RE: 1105 Front Street NE – The Cannery (Reference No. 24-106451-PLN) Completeness Response

Reference Nos.: 24-106451-PLN (Class 3 Site Plan Review, Tentative Subdivision Plan, Class 1 & 2 Adjustment, Class 2 Driveway Approach Permit)

PRELIMINARY SITE PLAN
THE CANNERY
FUND
SALEM, OREGON

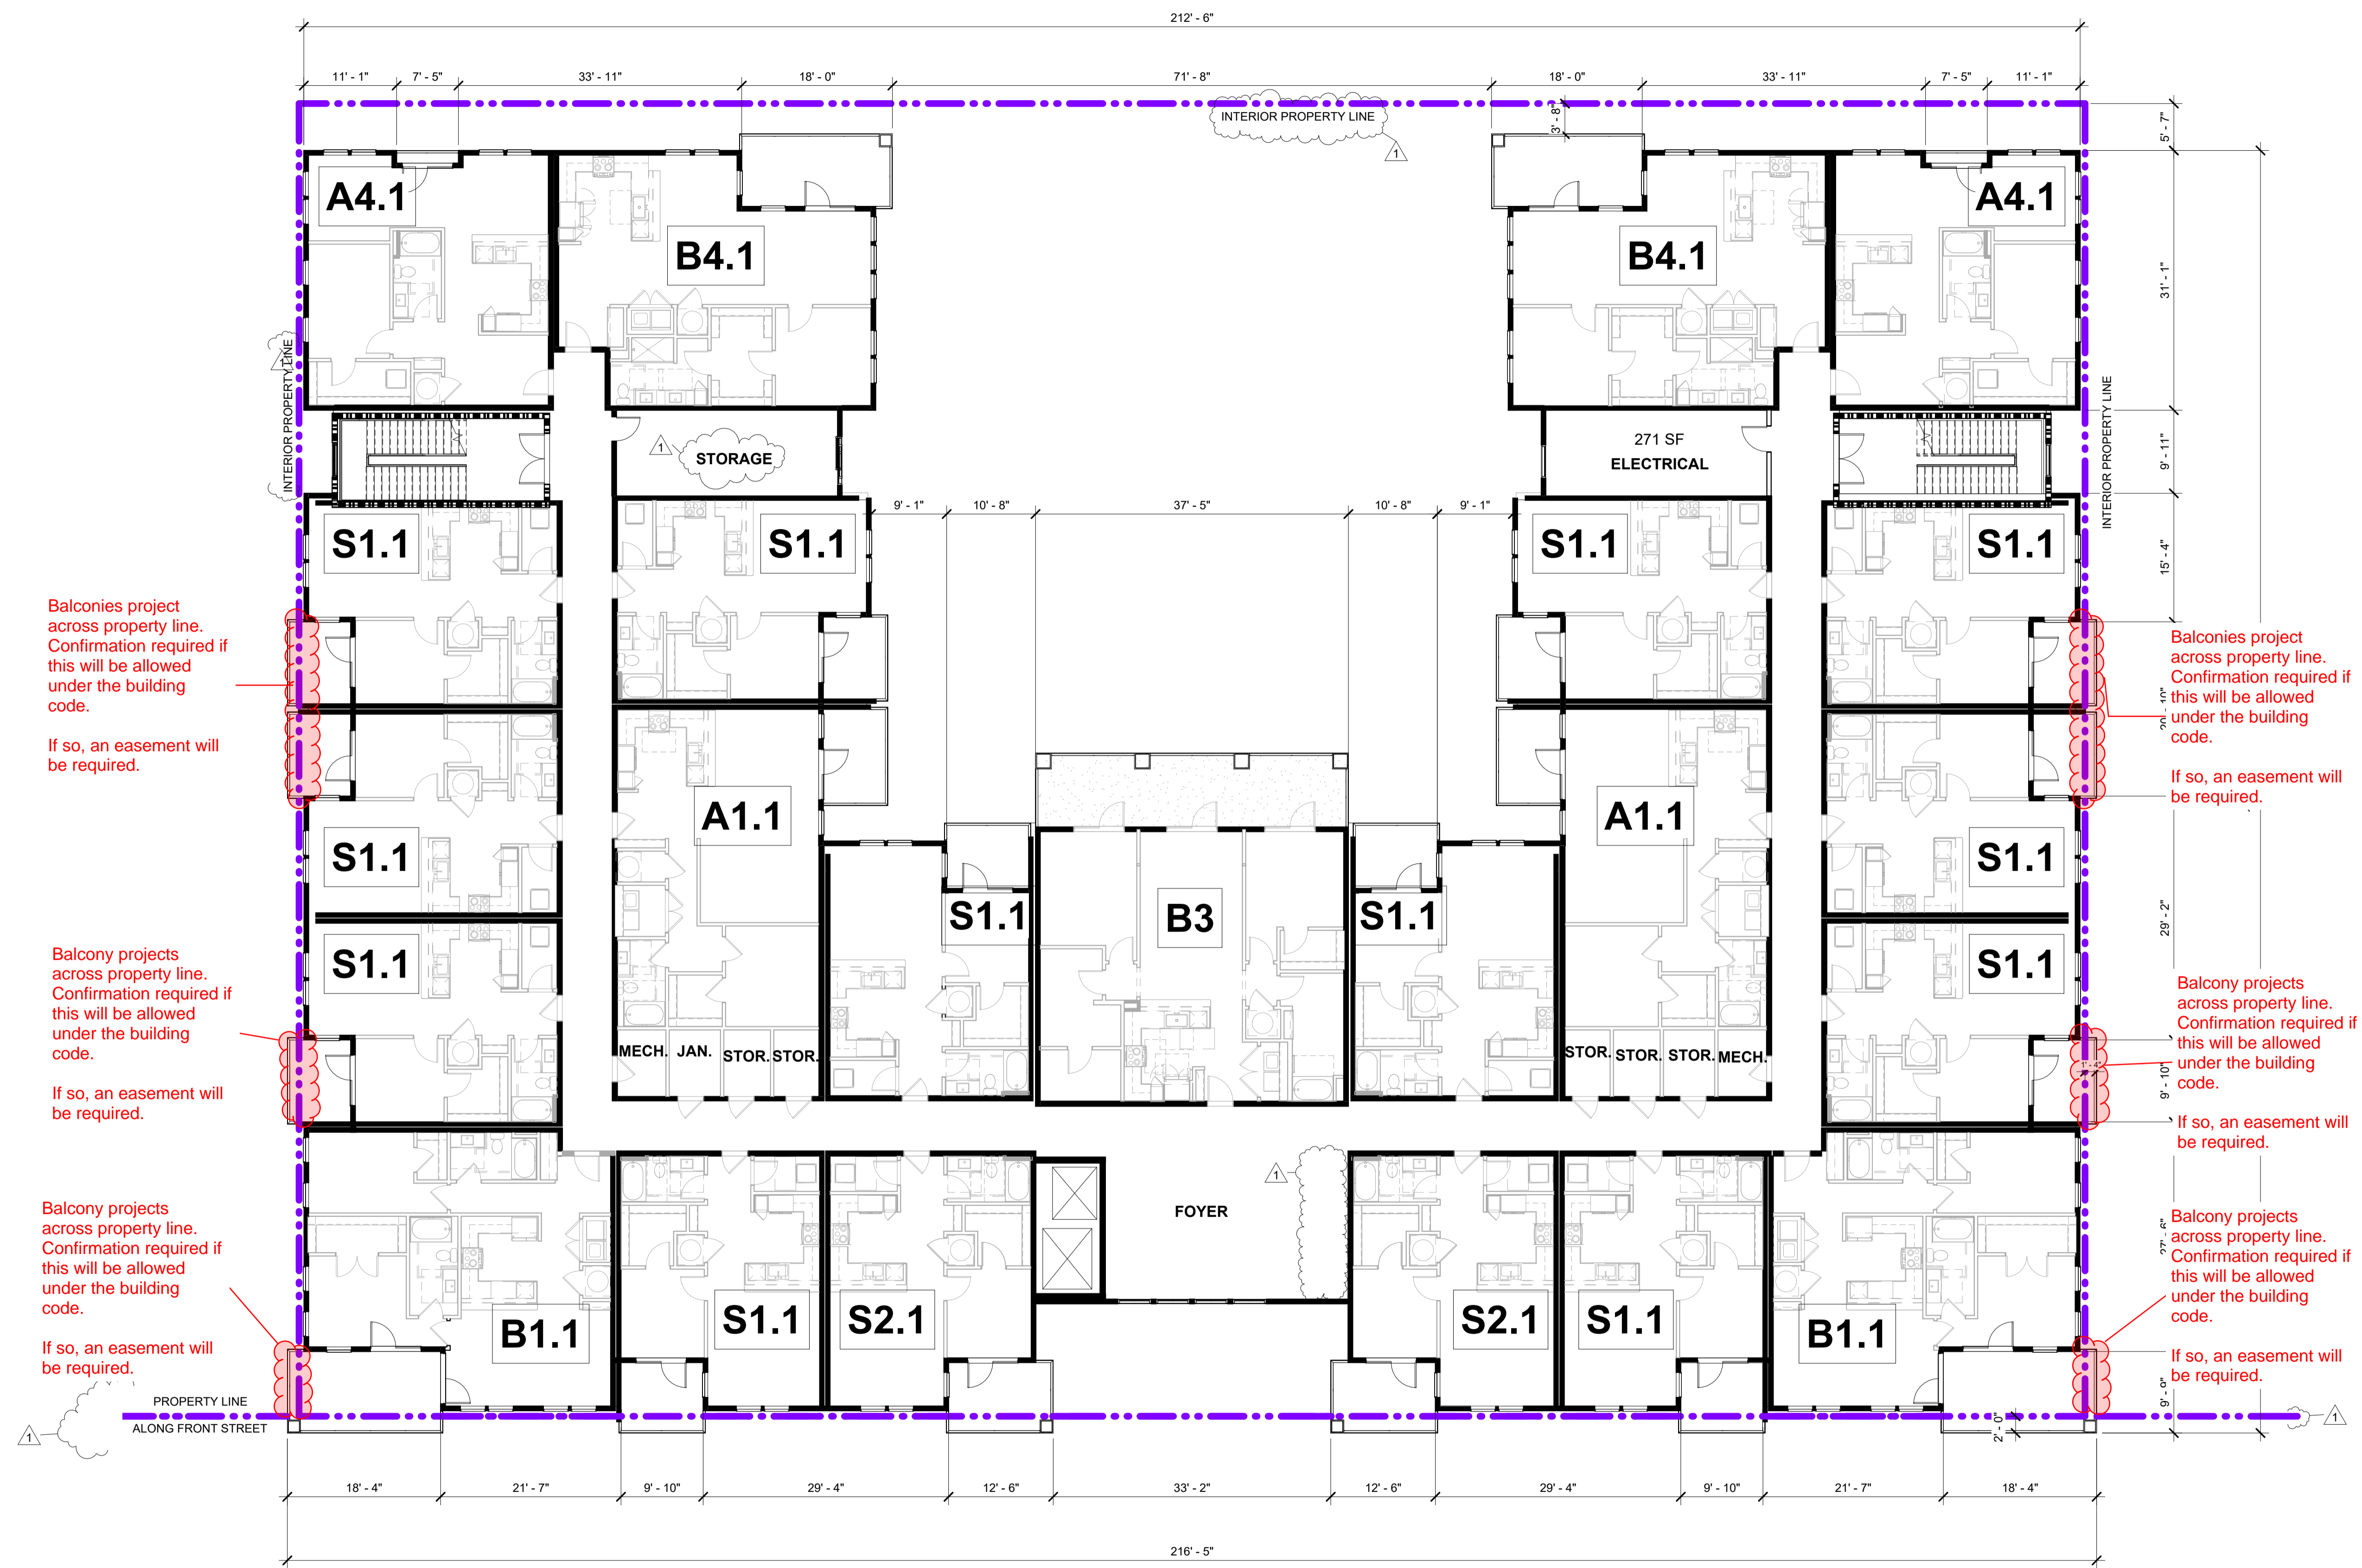
Balconies project across property line. Confirmation required if this will be allowed under the building code.
If so, an easement will be required.

Response: Planned property lines have been modified such that no canopies, balconies, or living space project across a property line as detailed on the revised Preliminary Building Elevations and Floor Plans in Attachment E. The 6th floor living space that projected into the Front Street NE right-of-way has been modified. This item is met.

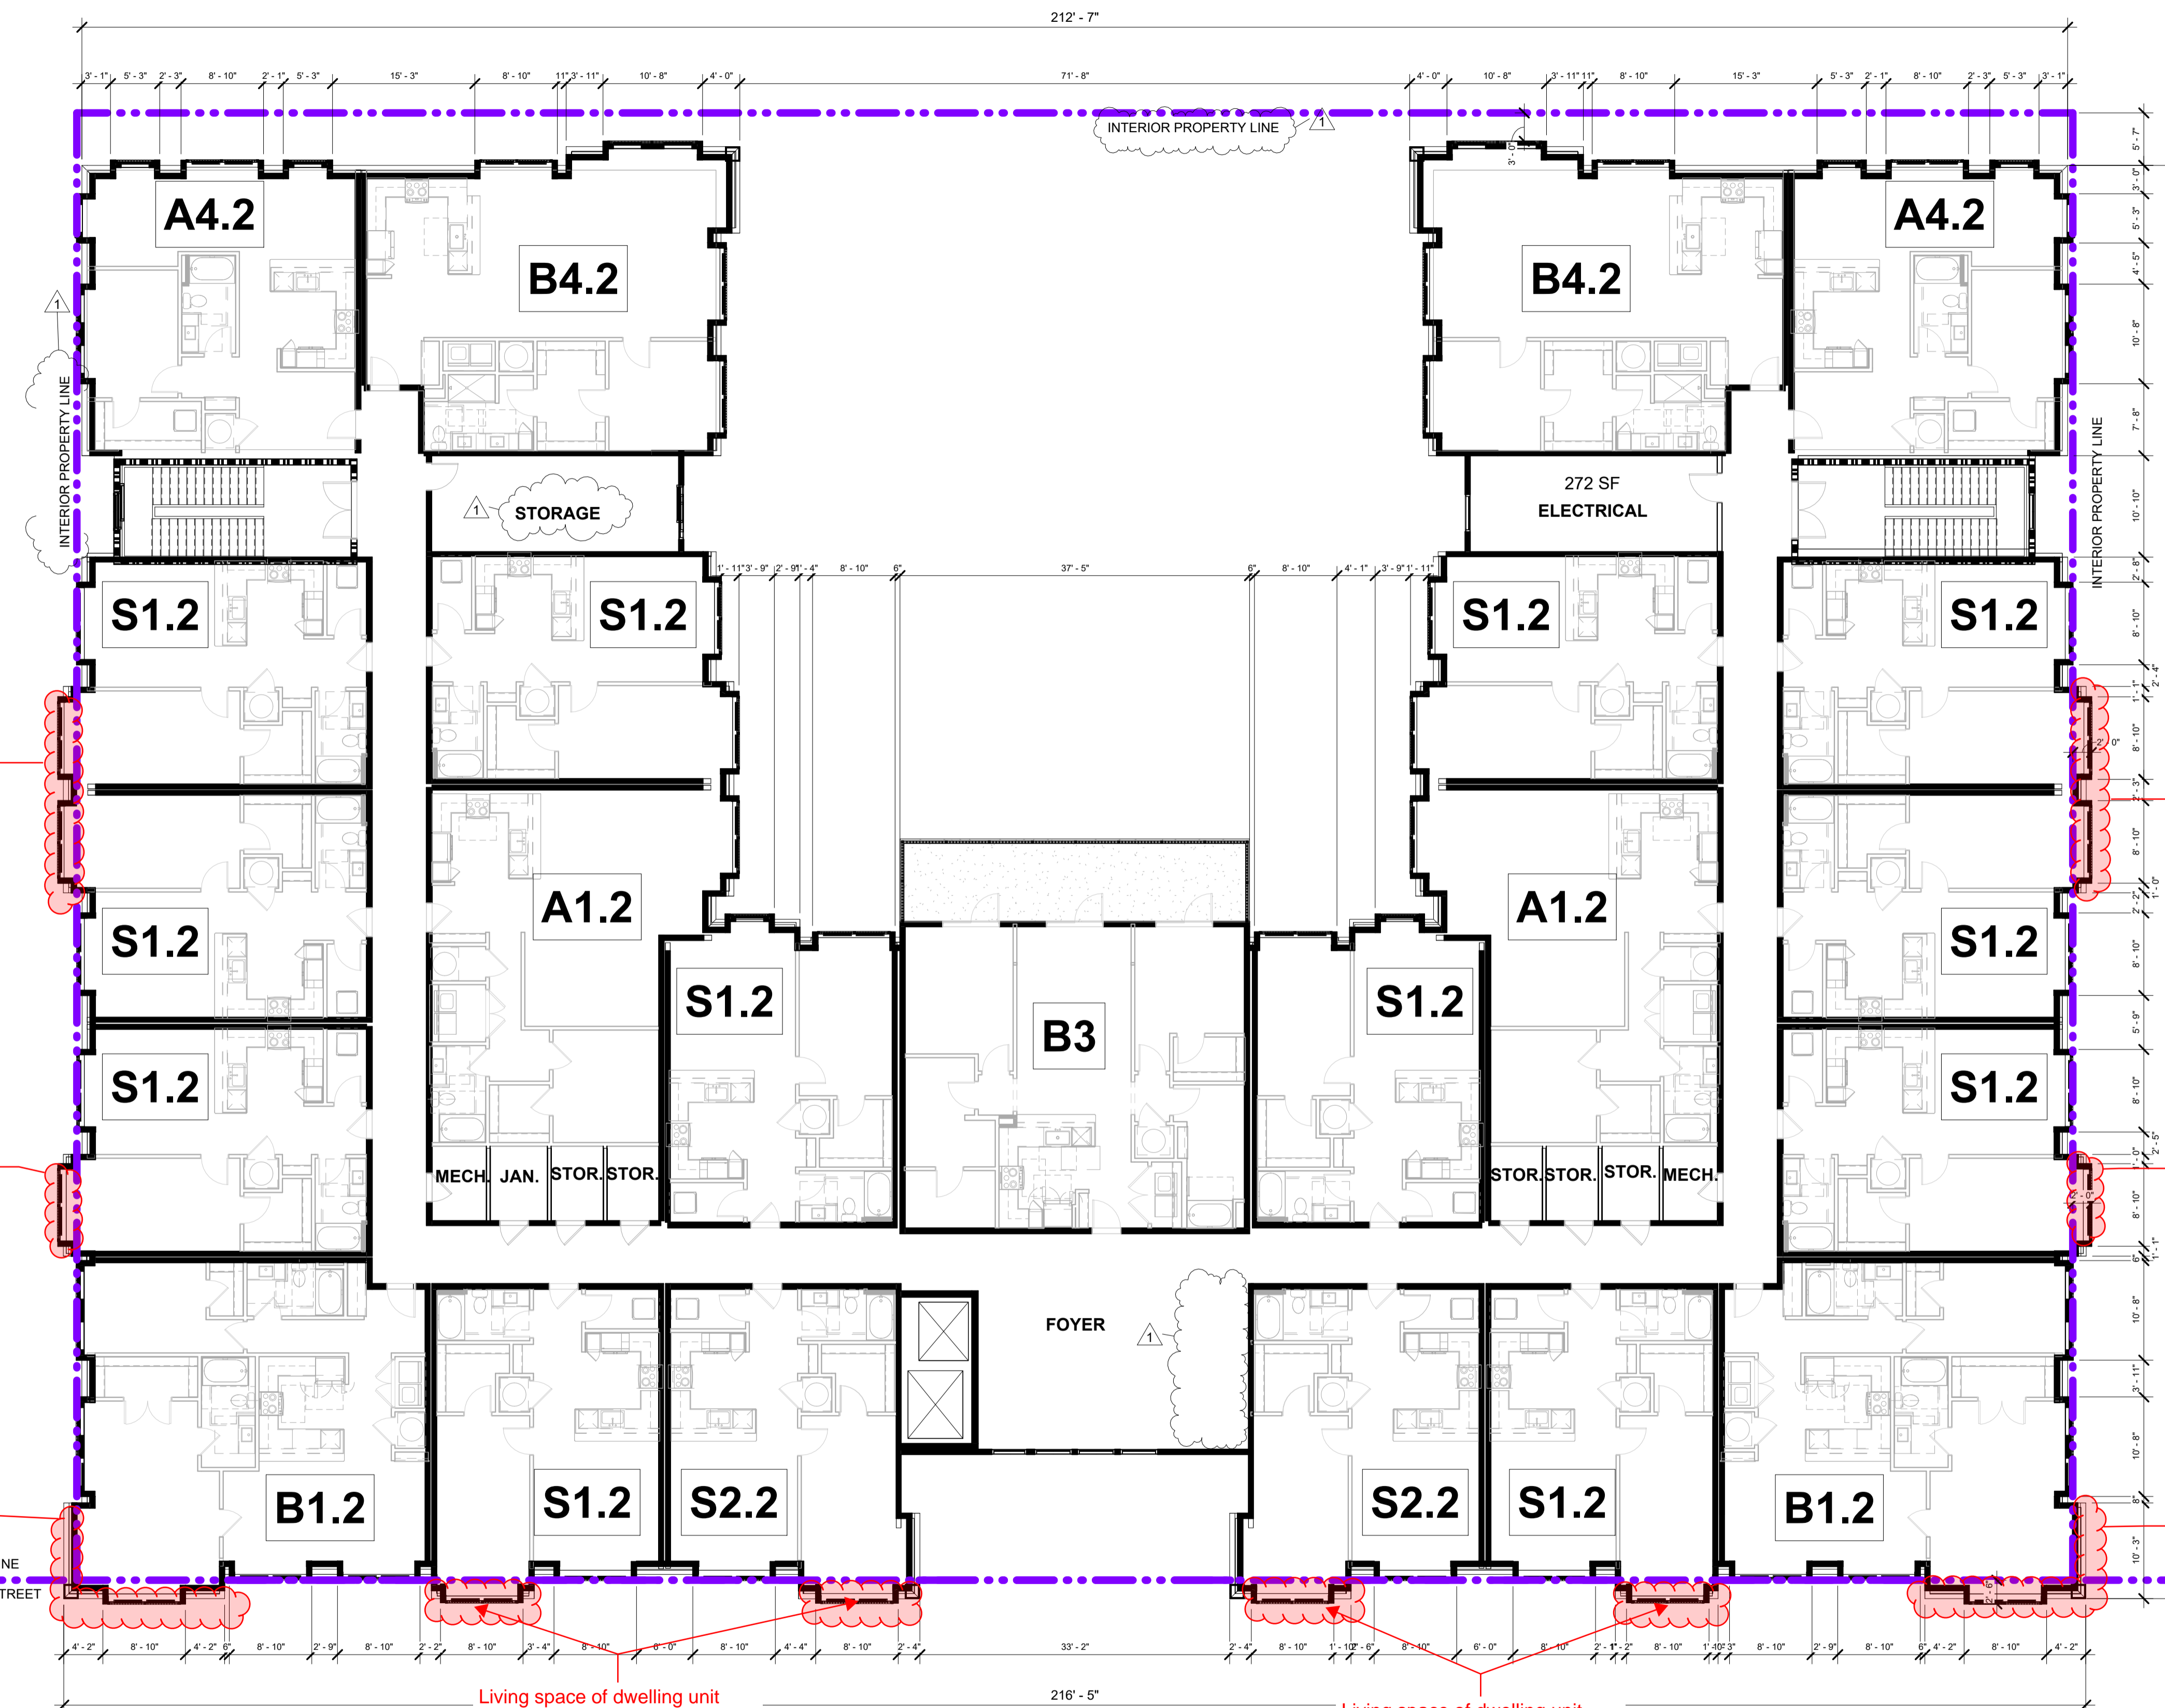
Living space of dwelling units project across property line. Confirmation required if this will be allowed under the building code.
If so, an easement will be required.

Living space of dwelling unit projects across property line. Confirmation required if this will be allowed under the building code.
If so, an easement will be required.

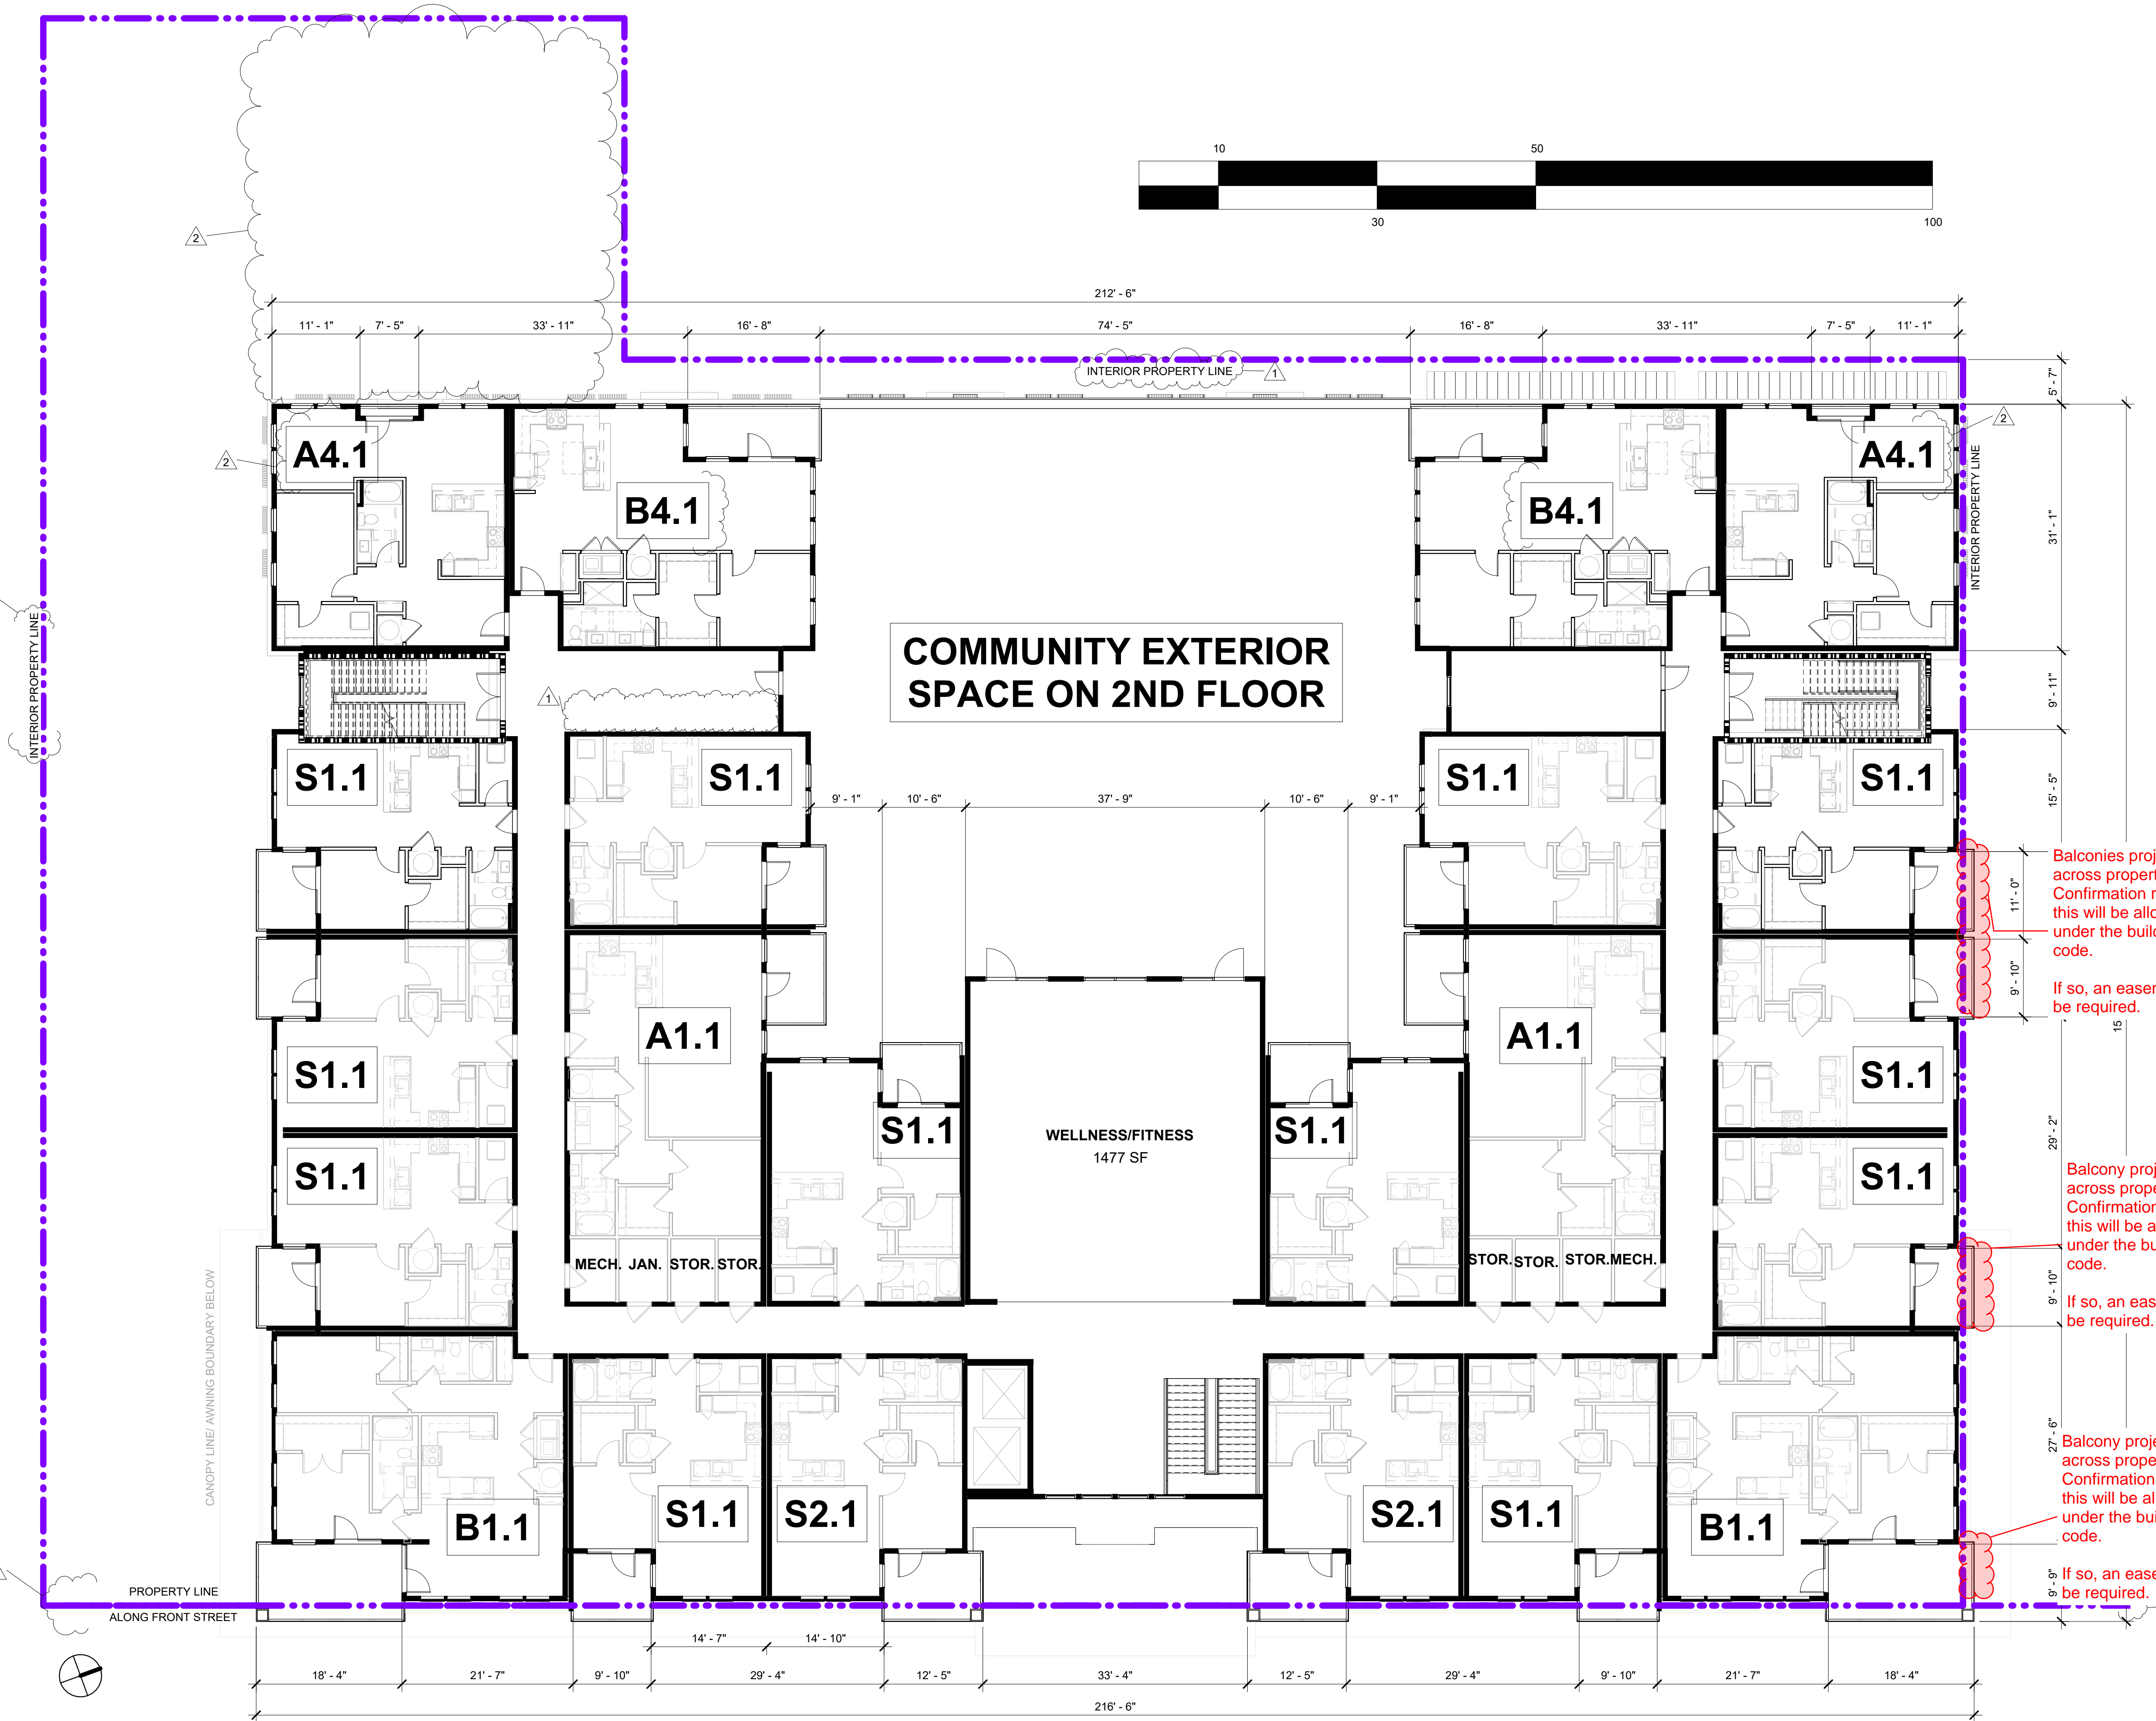
Balconies project across property line. Confirmation required if this will be allowed under the building code.

If so, an easement will be required.
